SMYRNA SCHOOL DISTRICT
Thomas D. Clayton Building Renovations
Bid Number SSD-15-004

ADDENDUM NO. 2 — 20 January 2016

ARCHITECT'S PROJECT NO: 14107e

DWN BY: MAB	CHK BY: KBF	PROJ. NUMBER: 14107E
DATE: 01-20-2016		DRAWING NUMBER: A40-01
SCALE: As indicated

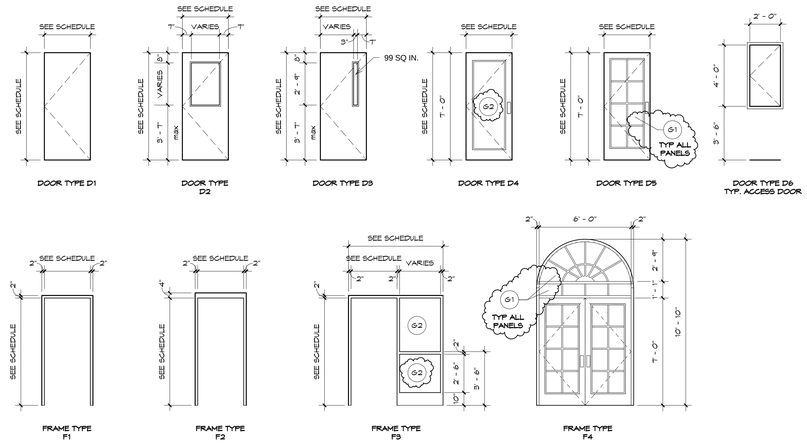
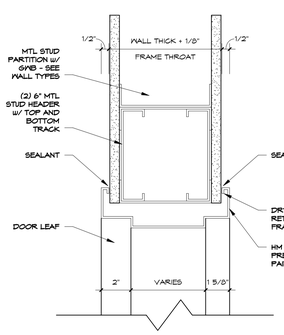
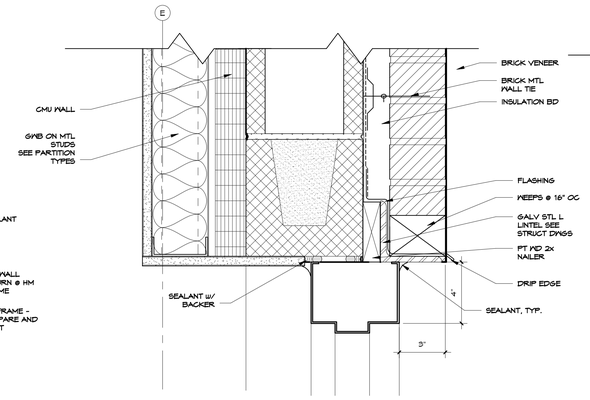
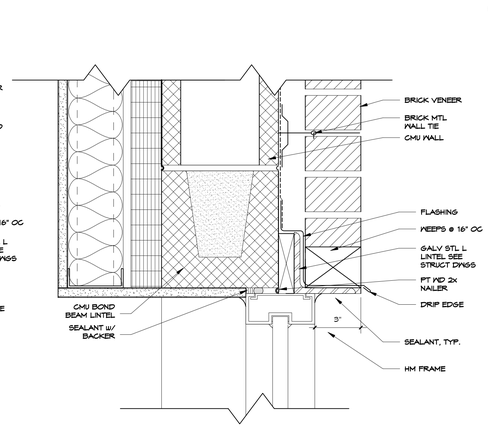
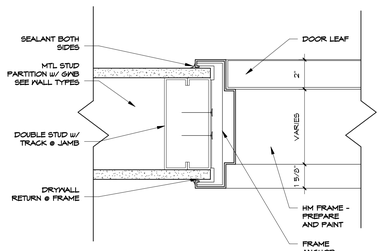
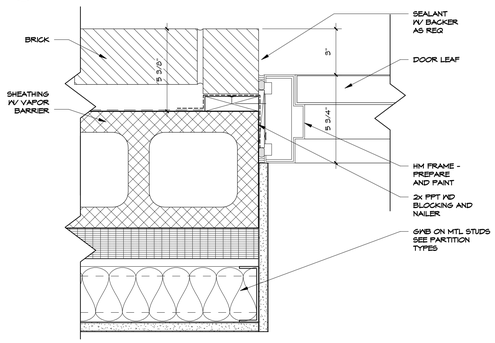
2.8 **Q:** Sheet A41-01 includes a Glazing Key, please indicate where these glazing numbers are being used.

2.12 **Q:** Several of the D3 type doors are designated as “smoke” doors. Do the doors require fire rated glazing and if so, what is the rating?”

A: Refer to revised Sheets A40-01 & A41-01.

A: Type D3 doors indicated as “smoke” doors do not require fire rated glazing. Only doors indicated as fire rated are required to meet fire rating indicated.

1 TYP WHITEBOARD MTG HGT

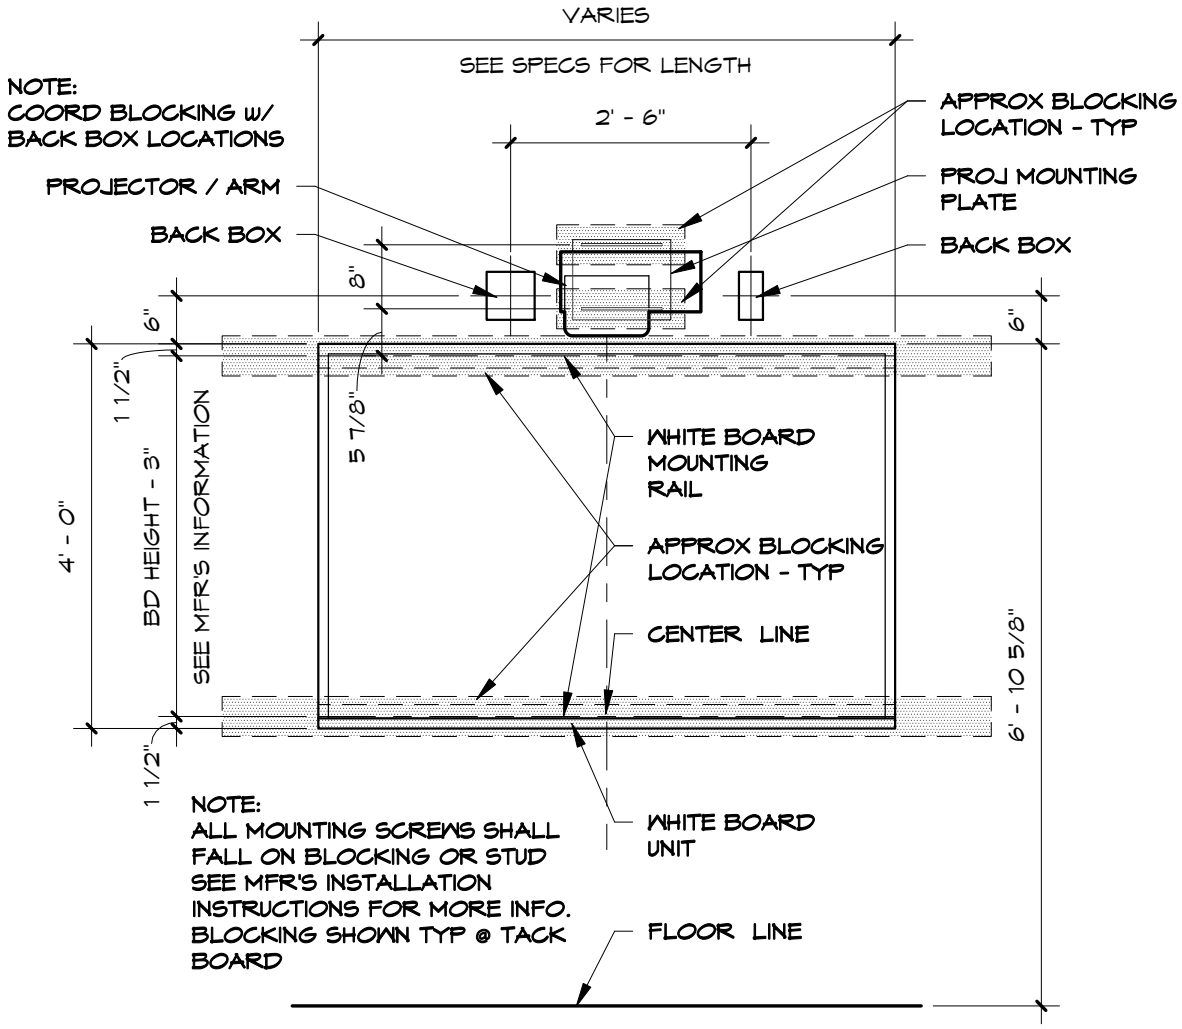
2.7 **Q:** Bid documents include specification section 101100 Visual Display boards. None are shown on drawings. Are they required for this project? If so, locations are needed.

A: See attached Specification Section 101100 Visual Display Boards and attached sketch A-SK-001.
